KM-3R

From serial no 1501 , the following changes are implemented:

Transmit Clock (X5)

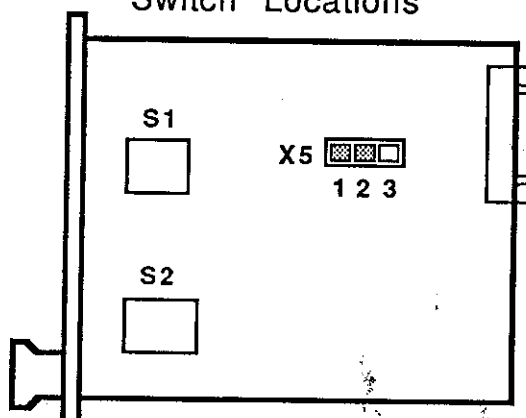
Transmit Clock Selection	X5 Jumper at
Internal Transmit Clock (114, pin 15)	1-2 (see note)
Receive Clock (115, pin 17) synchronizes Transmit Clock (114 , pin 15)	2-3 (See note)
External Transmit Clock (113, pin 24)	1-2

Note: Only connect pin 24, when External Clock is wanted.
A clock signal on pin 24 overrides any other selection.
